From: Richard Barnes <rwbarne73@gmail.com>
Sent: Saturday, 26 March 2022 1:46 PM
To: John Chrispijn
Cc: Colin McCoull; Dino De Paoli
Subject: Re: Deloraine Landfill - additional space for new cell
Attachments: Fig1_MVC_Flight_20220113.pdf

From: Richard Barnes [mailto:rwbarnes73@gmail.com]
Sent: Monday, 24 January 2022 9:00 PM
To: John Chrispijn; Dino De Paoli
Cc: Colin McCoull; Jarred Allen
Subject: Deloraine Landfill - additional space for new cell

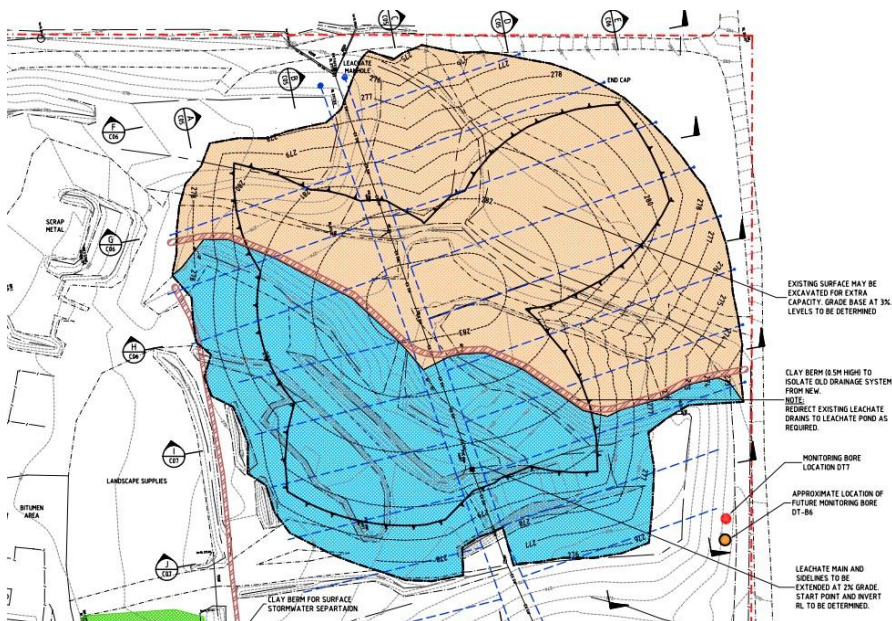
Also, and an aside, The image below is an extract of the design done in the SEMF EMP - it is the one we reused in the most recent EMP. I have noted that it shows some clay berms through the site (differentiates blue from orange areas) and also a clay berm along the southern edge where the existing buildings are and proposed WTS. I am not sure if the clay berms were installed. The area shown in the image below does extend beyond that area of what Colin has shown, so if that area (on the image below which is the orange and blue) there may be double the area, hence double the volume - it would still only be around 14,000 tonnes for a 2m lift.
